Access Compliance Report Public Rights-of-Way (Curb Ramps)

Main Street: WINDMILL_AVE		Cross Street: SIENNA_PKWY		Location:	E
ADA ID: RPRK211109120102	Ramp Type: Type 1 - Perpendicular	Initial Pass/Fail: Fail	Overall Compliance: No	Severity Score:	15
Codes/Mitigation Info/Possible Solution			Field Measurements/Component Compliance

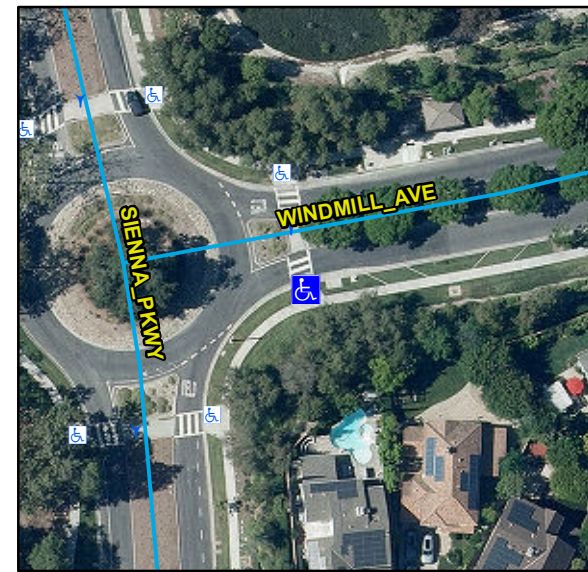
Compliance	Description	Data	Compliance	Description	Data
N/A	Ramp Length (in)	89	N/A	Flare Type LT	
Yes	Ramp Width (in)	48			N/A
No	Ramp Run Slope (%)	9.7	N/A	Flare Slope LT (%)	N/A
Yes	Ramp Cross Slope (%)	0.3	N/A	Flare Traversable LT	N/A
N/A	Landing Present	N/A	N/A	Flare Type RT	
N/A	Landing Length (in)	N/A			N/A
N/A	Landing Width (in)	N/A	N/A	Flare Slope RT (%)	N/A
N/A	Landing Run Slope (%)	N/A	N/A	Flare Traversable RT	N/A
N/A	Landing Cross Slope (%)	N/A	N/A	DWS Provided	N/A
N/A	Landing Movement Obstructed?	N/A	N/A	DWS Contrast	N/A
	Landing Movement Type	N/A	N/A	DWS Length (in)	N/A
N/A	Landing Shared	N/A	N/A	DWS Full Width	N/A
N/A	Clear Space	N/A	N/A	DWS Offset Left (in)	N/A
N/A	Clear Space To Crosswalk (in)	N/A	N/A	DWS Offset Right (in)	N/A
N/A	Marked Crosswalk 1	Yes	N/A	Marked Crosswalk 2	N/A
	Crossing 1 Direction	N		Crossing 2 Direction	N/A
	Marked Crosswalk 1 Width (in)	144		Marked Crosswalk 2 Width (in)	N/A

N/A	Ramp Inside Crosswalk 1	Yes	Yes	Ramp Inside Crosswalk 2	N/A
	Crossing 1 Slope (%)	3.5		Crossing 2 Slope (%)	N/A
	Crossing 1 Cross Slope (%)	0.4		Crossing 2 Cross Slope (%)	N/A
N/A	Gutter Ponding	N/A	No	Curb Slope	10.3
Yes	Gutter Lip Height (in)	0		Road Run Slope (%)	N/A
N/A	Gutter Run Slope (%)	N/A		Road Cross Slope (%)	N/A
N/A	Gutter Cross Slope (%)	N/A			
Yes	Overall Surface Condition: Acceptable		No	Perp Joint Present	No
	Cross Gutter Present?	No		Spandrel Present?	No
	Replace Cross Gutter?	N/A		Replace Spandrel?	N/A

Remove & Replace Entire Ramp.

R304.2.2, R204.3, STD 1115
